Application No.	Applicant(s)
Notice of Allowability	10/784,037 Examiner	OZAWA ET AL. Art Unit
	Timothy L. Rude	2871
The MAILING DATE of this communication appears on the cover sheet with the correspondence address All claims being allowable, PROSECUTION ON THE MERITS IS (OR REMAINS) CLOSED in this application. If not included herewith (or previously mailed), a Notice of Allowance (PTOL-85) or other appropriate communication will be mailed in due course. THIS NOTICE OF ALLOWABILITY IS NOT A GRANT OF PATENT RIGHTS. This application is subject to withdrawal from issue at the initiative of the Office or upon petition by the applicant. See 37 CFR 1.313 and MPEP 1308.

DETAILED ACTION

Allowable Subject Matter

Figure 6(B):

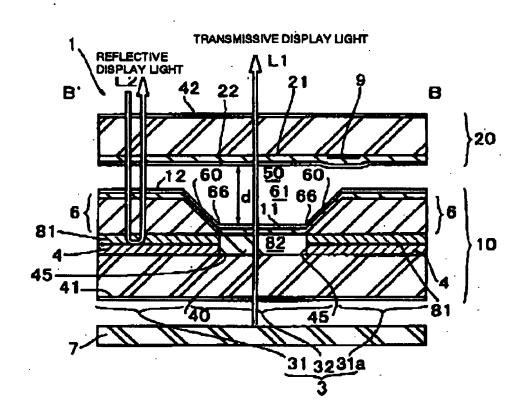
As to independent claims 1, 9, 19, and 20, relevant prior art did not teach, alone or in combination, the transflective liquid crystal display device as claimed comprising a thickness adjusting layer, 6, having an edge substantially proximate to the transmissive display region and a sloping section, 60, that extends from the edge in a direction away

from the corresponding substrate, the edge of the thickness adjusting layer and the slope at least adjacent to the edge being overlapped by a portion of the light-reflecting layer, 4. This structure prevents unwanted transmitted light leakage through the sloped region.

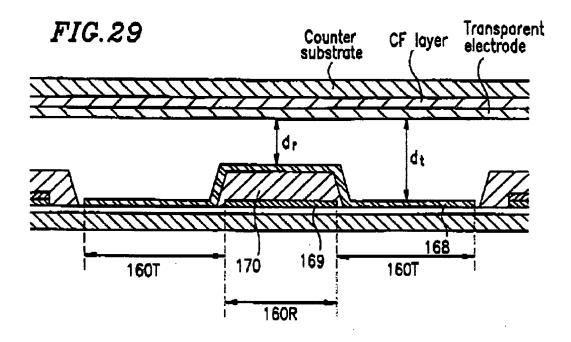
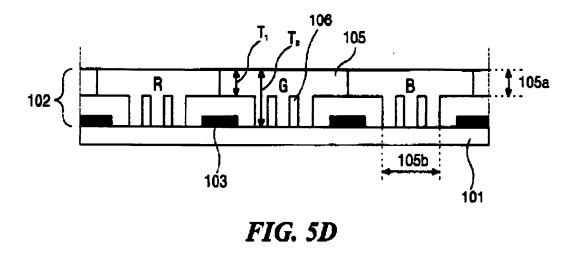
Kubo discloses a transflective liquid crystal device [electronic apparatus, TFTs] comprising:

a light-reflecting layer, 169, overlapping reflective display regions in plan view in pixel regions and in a non-overlapping condition with transmissive display regions in the regions of the pixel regions other than the reflective display regions; and

a thickness-adjusting layer, 170, setting the thickness of the liquid crystal layer in the reflective display regions to be smaller than the thickness of the liquid crystal layer in the transmissive display regions; and Art Unit: 2871

slopes are formed in the thickness-adjusting layer at a transition between each reflective display region and transmissive display region; and

edges of the light-reflecting layer adjacent the transmissive display regions are substantially aligned with bottom edges of the slopes of the thickness-adjusting layer [steep slope so reads on substantially aligned per Figure 29].

Kubo does not explicitly disclose a device further comprising reflective-display color filters in the reflective display regions and transmissive-display color filters, which are colored more strongly than the reflective-display color filters, in the transmissive display regions.

However, no reference with proper motivation to combine was found to teach the claimed thickness adjusting layer having an edge substantially proximate to the transmissive display region and a sloping section that extends from the edge in a direction away from the corresponding substrate, the edge of the thickness adjusting layer and the slope at least adjacent to the edge being overlapped by a portion of the light-reflecting layer. Commonly owned references are not considered to read on the newly added claim limitations.
